GRADING AND DRAINAGE PLAN

Santuario
San Martin De Porres
8301 Camino San Martin SW
Westgate Heights
Albuquerque, NM 87121

JANUARY 25, 2010
**SITE PLAN
FOR
BUILDING PERMIT**

ADMINISTRATIVE AMENDMENT

CONCEPTUAL SITE PLAN

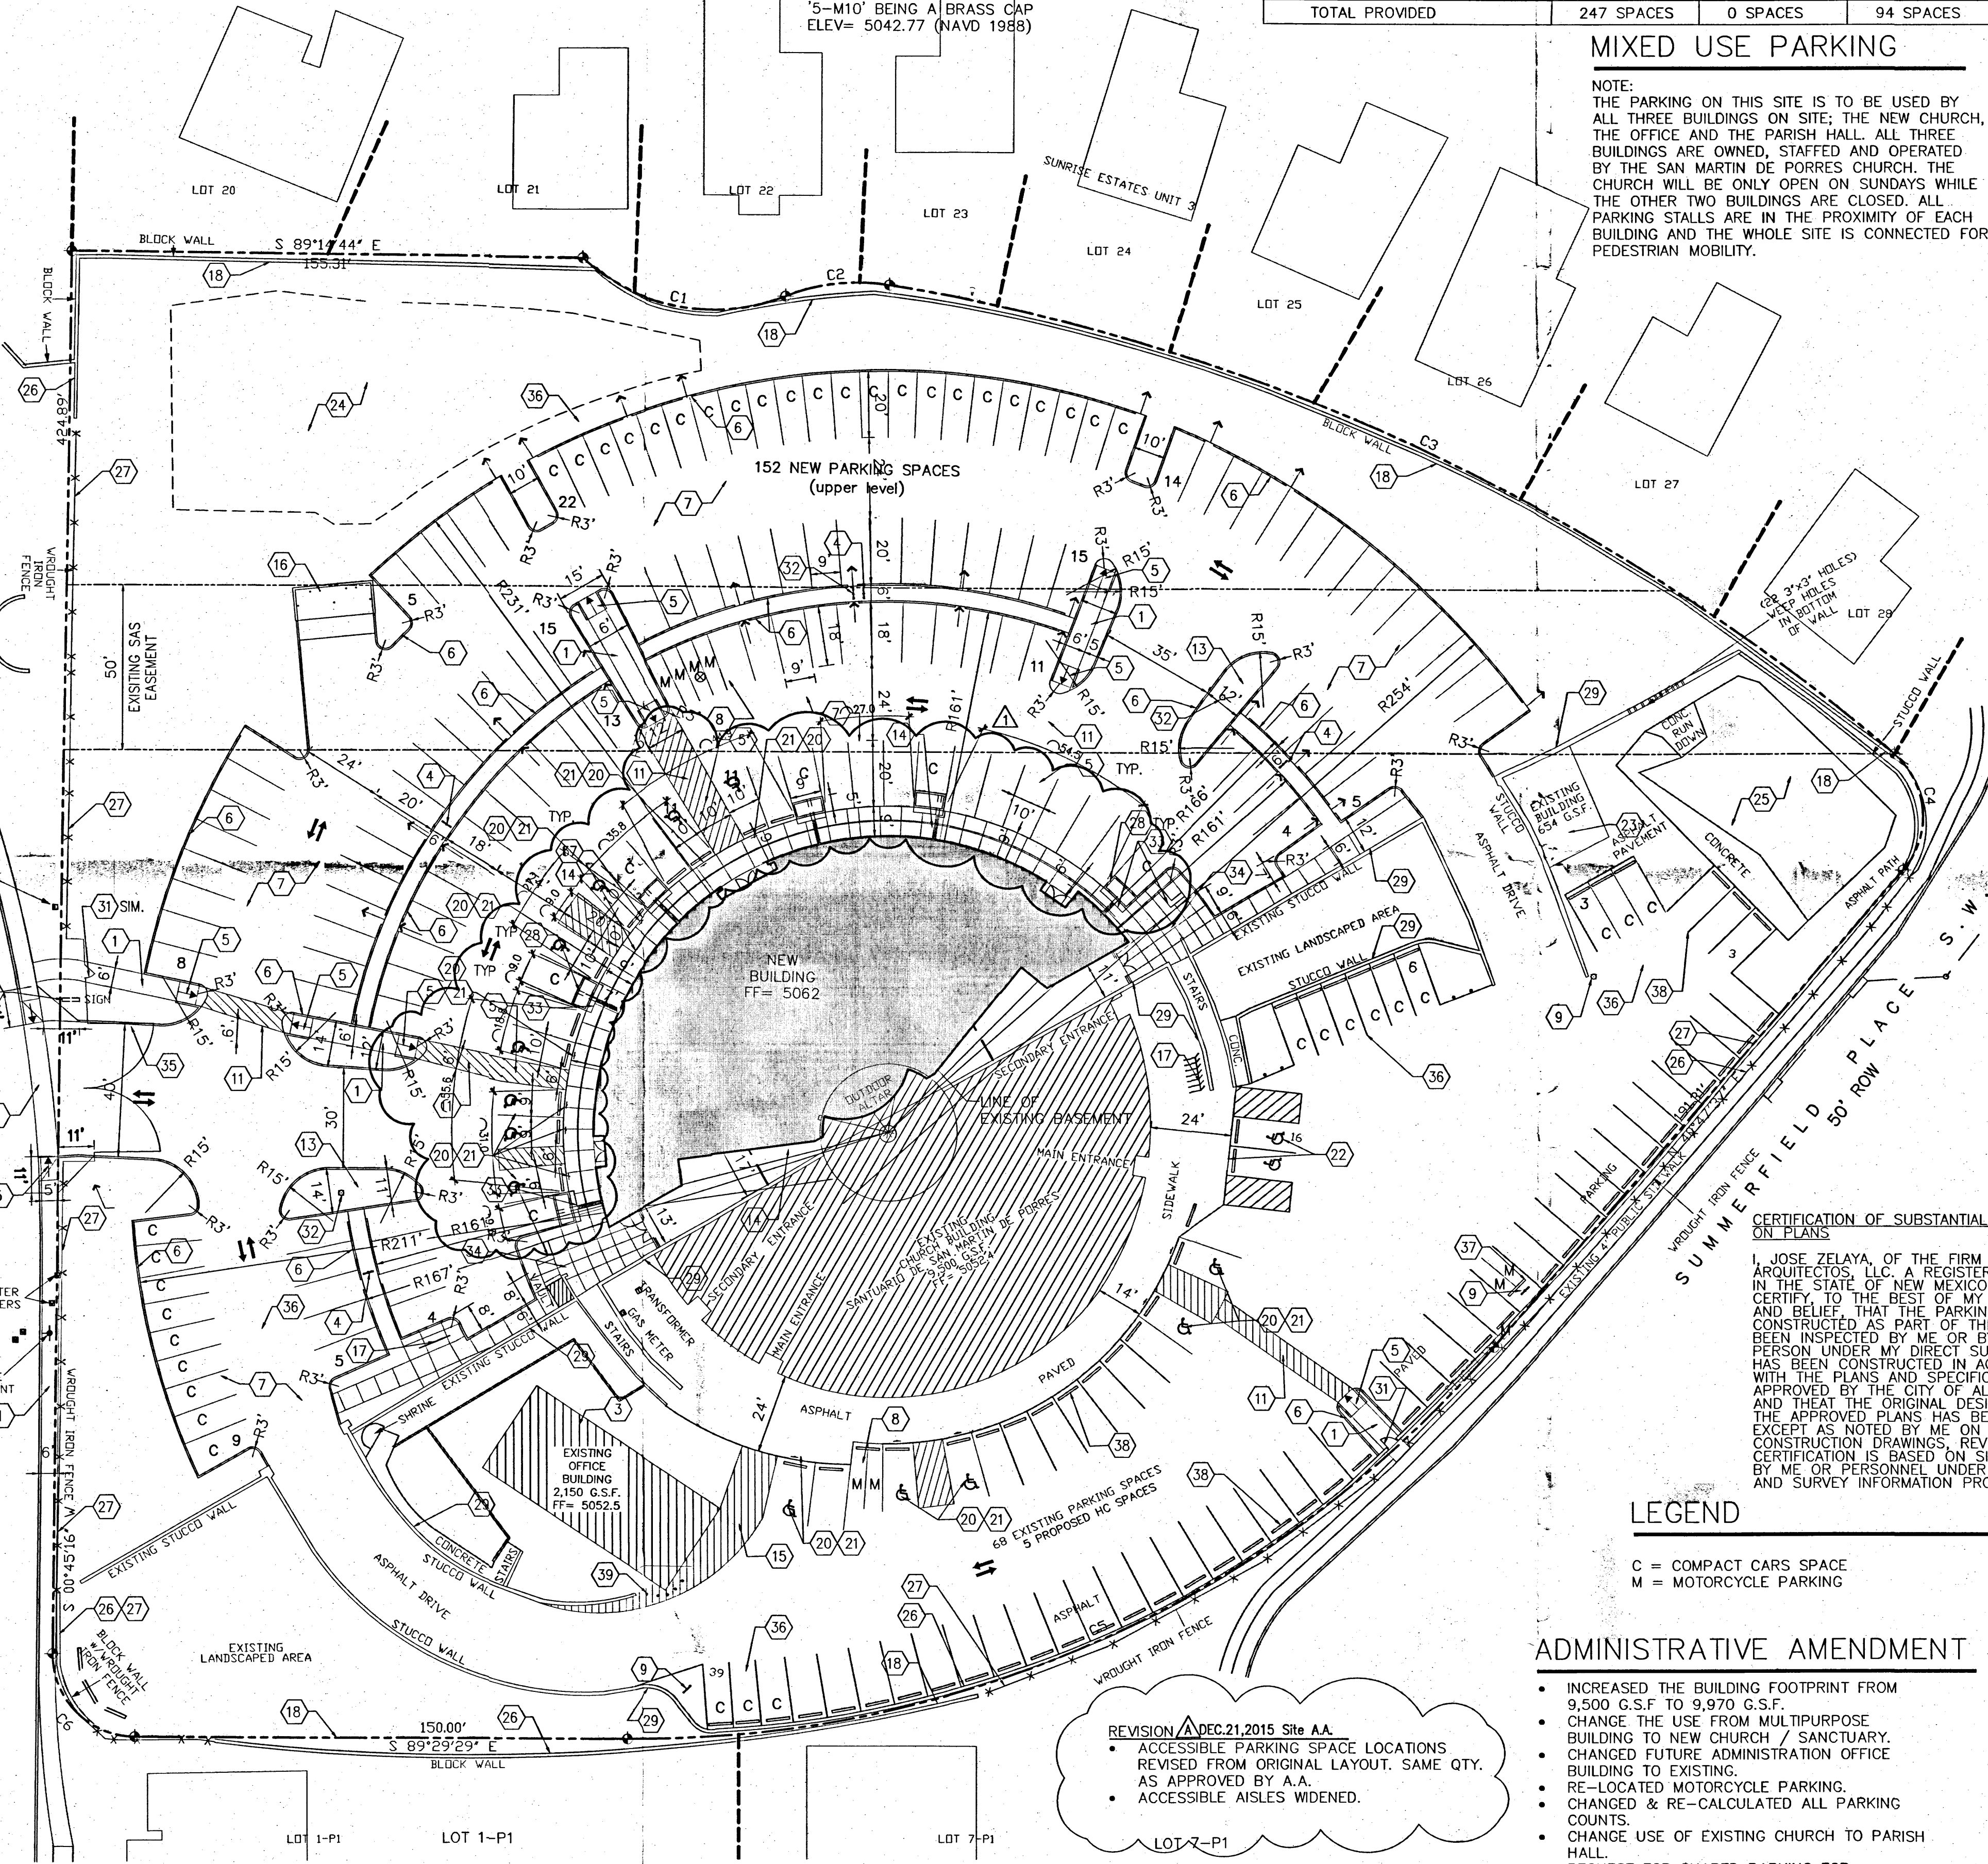
- INCREASED THE BUILDING FOOTPRINT FROM 9,500 G.S.F. TO 9,970 G.S.F.
- CHANGE THE USE FROM MULTIPURPOSE BUILDING TO NEW CHURCH / SANCTUARY.
- CHANGED FUTURE ADMINISTRATION OFFICE BUILDING TO EXISTING.
- RE-LOCATED MOTORCYCLE PARKING.
- CHANGED & RE-CALCULATED ALL PARKING COUNTS.
- CHANGE USE OF EXISTING CHURCH TO PARISH HALL.
- REQUEST FOR SHARED PARKING FOR NON-CONCURRENT USE.

REVISION DEC-21-2015 Site AA
ACCESSIBLE PARKING SPACE LOCATIONS REVISED FROM ORIGINAL LAYOUT. SAME QTY. AS APPROVED BY A.A.
ACCESSIBLE AISLES WIDENED.
